80296SA MICROCONTROLLER SPECIFICATION UPDATE

Release Date: February, 1997

Order Number: 272908-006

The 80296SA may contain design defects or errors known as errata. Characterized errata that may cause the 80296SA's behavior to deviate from published specifications are documented in this specification update.

9600004. Address, Data, EPORT Pins Weakly Held High During Hold

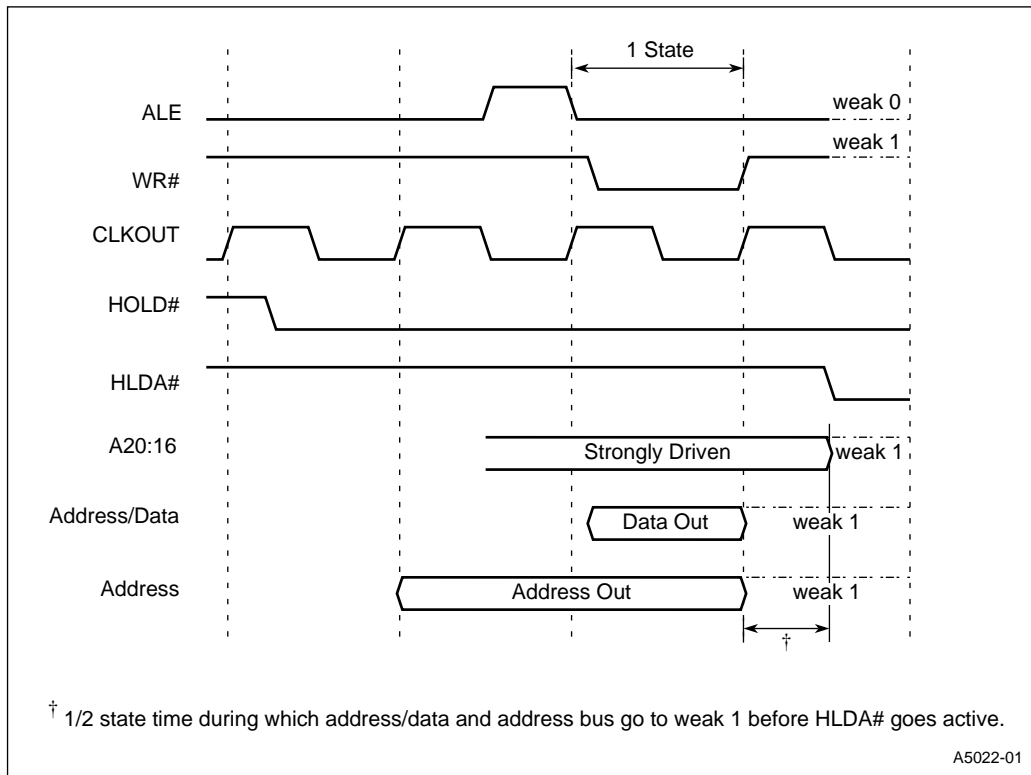
PROBLEM: The pin status table in the *80296SA Microcontroller User's Manual* states that the address bus, EPORT, and address/data bus should be high-impedance during hold, but these pins are weakly held high instead.

IMPLICATION: Potential bus contention could occur if the device driving the bus is not strong enough to drive the weakly held high signals to the desired state.

WORKAROUND: Do not use hold or ensure that the device driving the bus can overcome the weak driver.

Behavior of Bus Signals When Entering Bus Hold

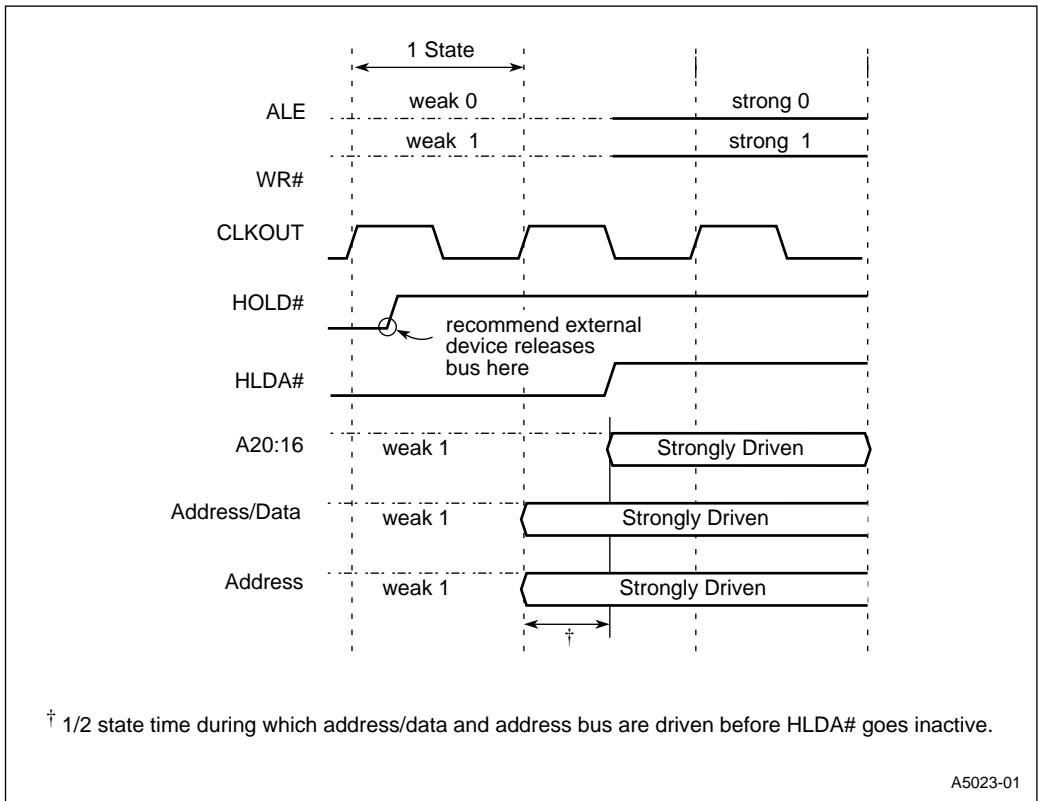
PROBLEM: When going into bus hold, the address/data bus and address bus pins go to their hold values about 1/2 state early before HLDA# goes low. The other bus signals, such as the EPORT, ALE, RD#, WR#, etc., remain strongly driven for about 1/2 state longer until HLDA# goes active. Please refer to the diagram:

IMPLICATION: In the figure above, a write cycle is occurring just before the 80296SA releases the bus and goes into hold mode. This write cycle cannot be relied upon, since the 80296SA stops driving valid information on the address and address/data bus at nearly the same time as WR# goes high. The address behaves the same as in normal bus cycles. The data is held longer, though, in the normal bus cycle.

This may make bus hold unreliable and unusable.

WORKAROUND: There is no workaround unless the device receiving data does not expect the data to be held after rising edge of WR#.

022. Replace T_{CHYX} specification with T_{CH1YX} and T_{CH2YX} for both multiplexed and demultiplexed modes; replace READY timing diagrams (Datasheet)

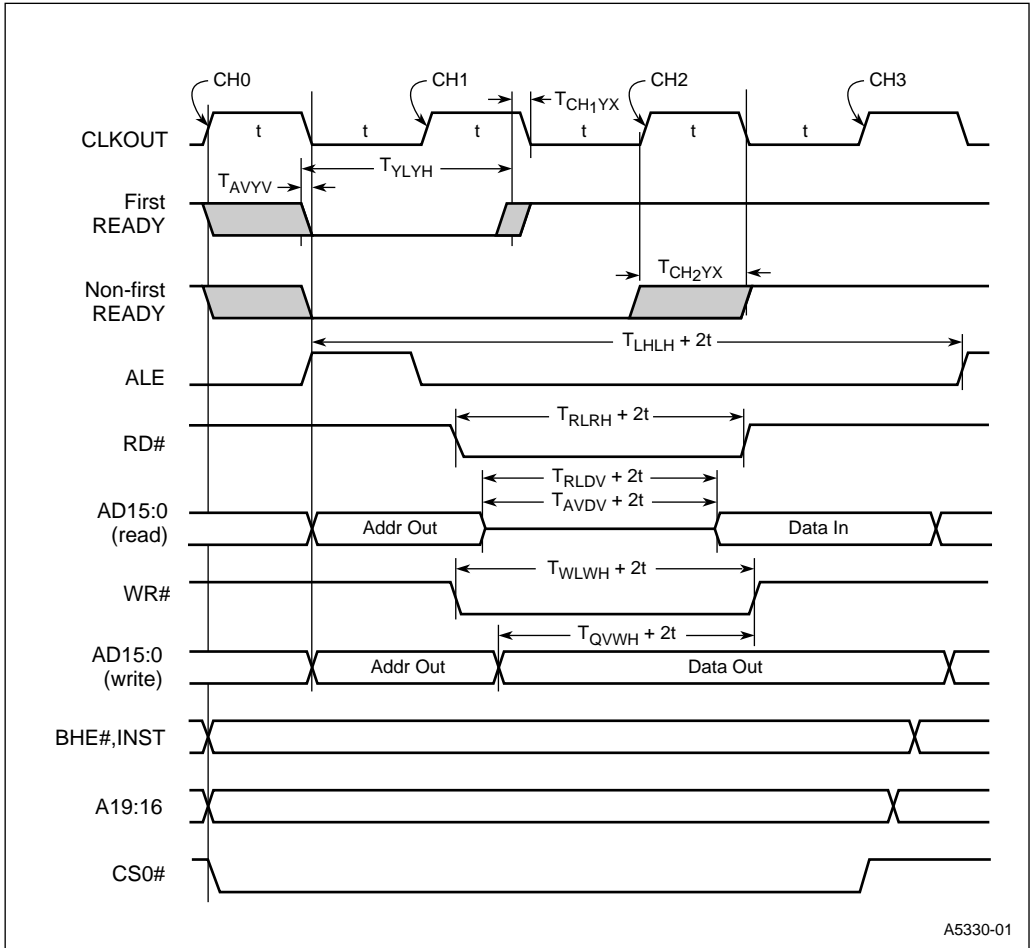
PROBLEM: The T_{CHYX} specification has been replaced by two specifications, T_{CH1YX} and T_{CH2YX} , to more clearly define the timing requirements for the first READY pulse and for subsequent READY pulses.

1. If using the READY signal to insert wait states, you must program at least one wait state in the BUSCONx register because the first falling edge of READY is not synchronized with a CLKOUT edge.
2. If using the BUSCONx register **without** the READY signal to insert wait states, add $2t \times n$, where n = number of wait states.
3. If using the BUSCONx register to insert wait states, add $2t \times (n-1)$, where n = number of wait states.
4. Exceeding the maximum specification causes additional wait states.
5. If you program two or more wait states in the BUSCONx register, the T_{CH1YX} minimum does not apply.
